- 2. ZONING BY-LAW AMENDMENT – 2 FOURTH AVENUE, 364, 368, 370 AND 372 QUEEN ELIZABETH DRIVEWAY AND 1 FIFTH AVENUE**
- MODIFICATION DU RÈGLEMENT DE ZONAGE – 2, AVENUE FOURTH, 364, 368, 370 ET 372, PROMENADE QUEEN ELIZABETH ET 1, AVENUE FIFTH**

**File Number: ACS2015-PAI-PGM-0128**

**SUBJECT: Zoning By-law Amendment – 2 Fourth Avenue, 364, 368, 370 and 372  
Queen Elizabeth Driveway and 1 Fifth Avenue**

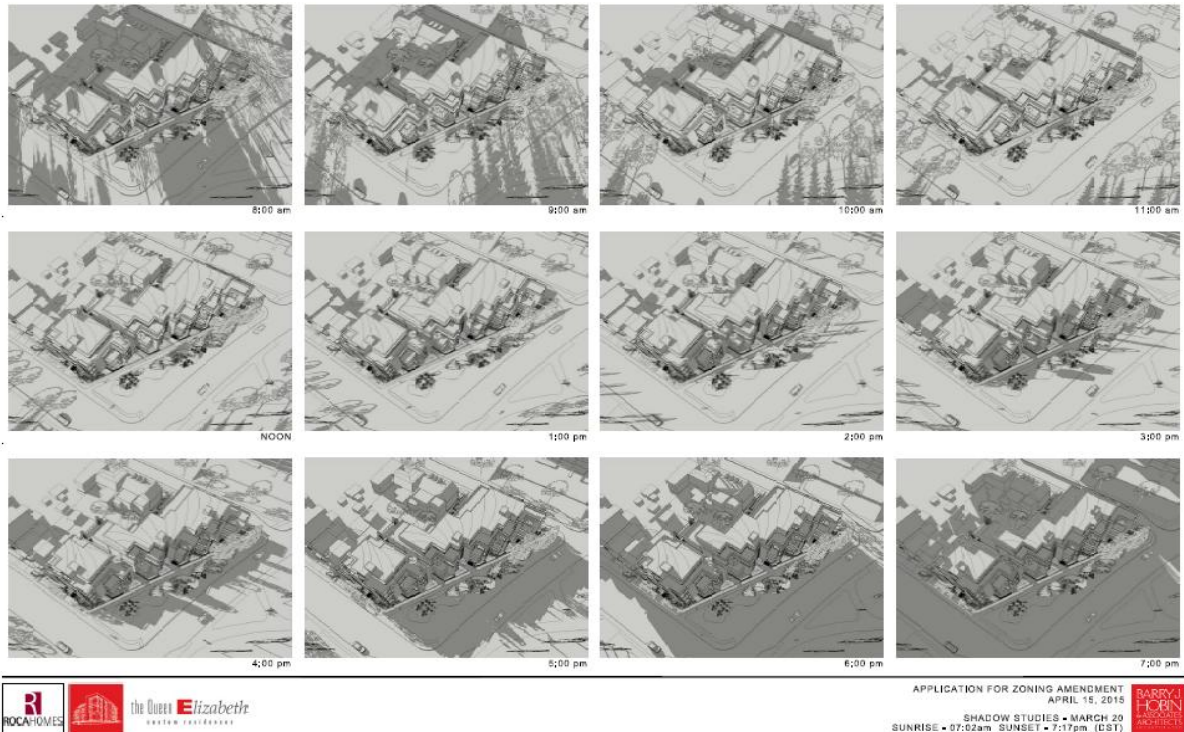
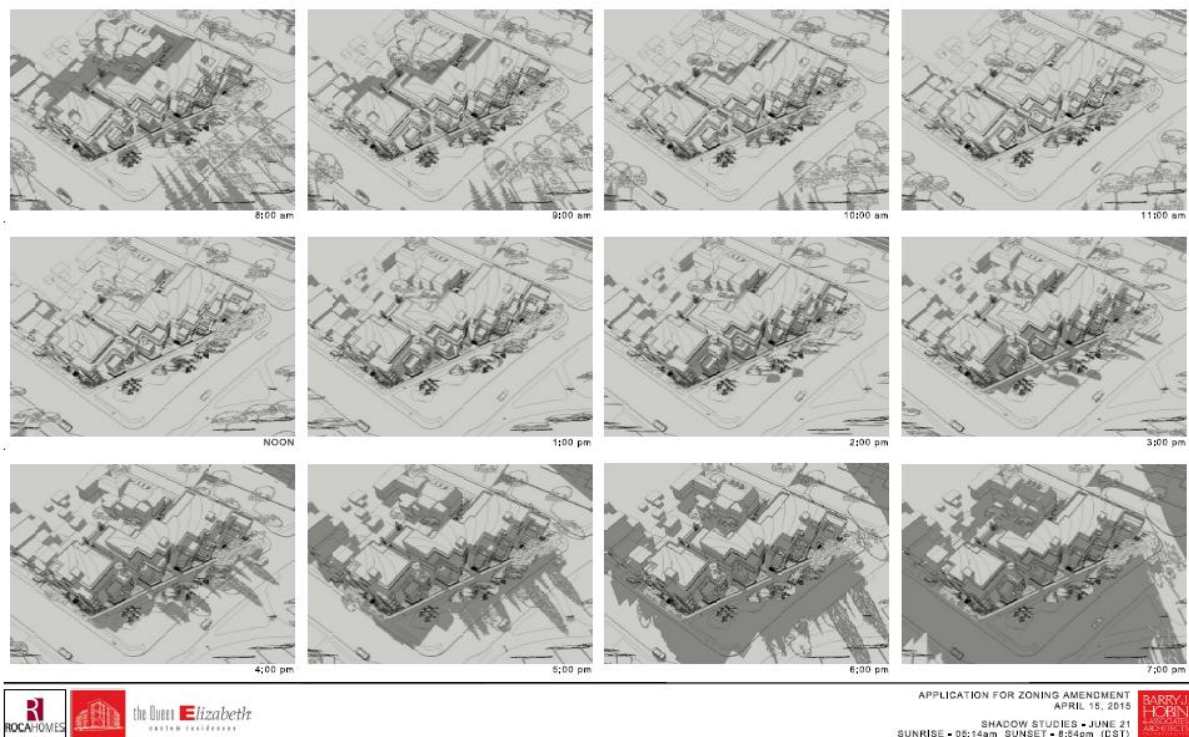
The shadowing studies provided appear to contradict the statement made in the Planning Rationale provided that states that shadowing really only occurs at 8 am (these being based on June readings). The studies provided for both March and December indicate significant backyard shading (of Fourth Ave addresses) will occur until 10 or in fact 11 am.

Most significantly felt by adjacent neighbours on 4<sup>th</sup> Avenue, the shadowing studies provided appear to contradict the statement made in the Planning Rationale provided that states that shadowing really only occurs at 8 am (these being based on June readings). The studies provided for both March and December indicate significant backyard shading will occur until 10 or in fact 11 am. Further, statements made in the Planning Rationale [prepared by the applicant's planning consultant] indicate the maximum allowable building massing under existing zoning would not be materially different from that proposed under the proposed R4 which would allow for partial 4<sup>th</sup> storey, but no documentation is provided to support that claim.

The shadows that the proposed buildings are projected to throw are shown in Document 2. Three-storey buildings constructed to the zoning limits under the existing

zoning would also have the potential to create shadow. The shadow impacts of the fourth floor are lessened by the step back.
